The Canberra Brickworks and Environs
Planning and Development Strategy
September 2013, including the preferred option

Yarralumla Residents Association

Submission

10 July 2014

Fig.7 - Bushfire requirements for site

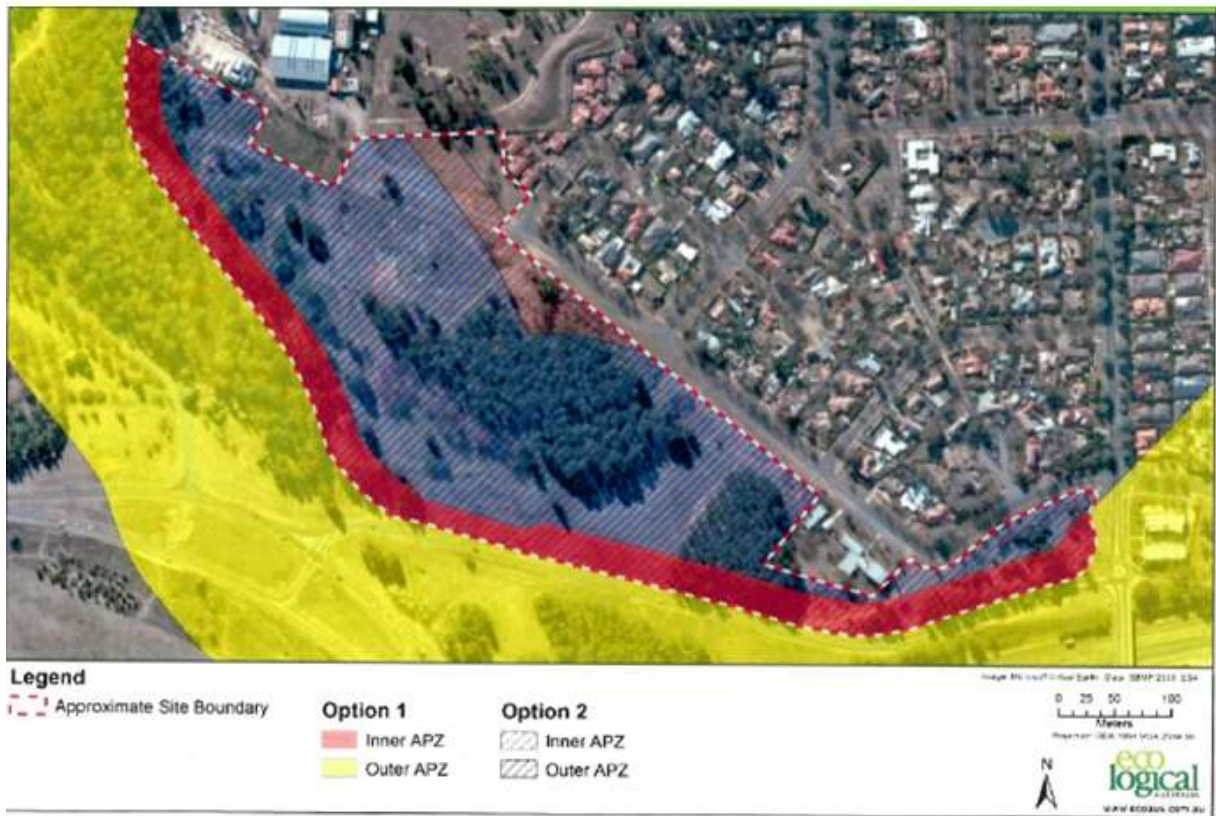
- 14.4 The APZs required for new development in this area as assessed by the National Capital Authority (NCA 2012) are: a 30m wide inner APZ on the western and southern edge; a 20m wide inner APZ where grassland adjoins the boundary on the south-western corner; and a minimum 200m wide outer APZ where forest/shrubland adjoins the boundary along the western and southern edge.

- 14.5 These requirements are set out on Fig.7 (Option1) and it appears that this cannot be achieved with the current proposed development and to do so will reduce the developable area on the site and hence its feasibility. This needs to be taken into account in the assessment of the site.
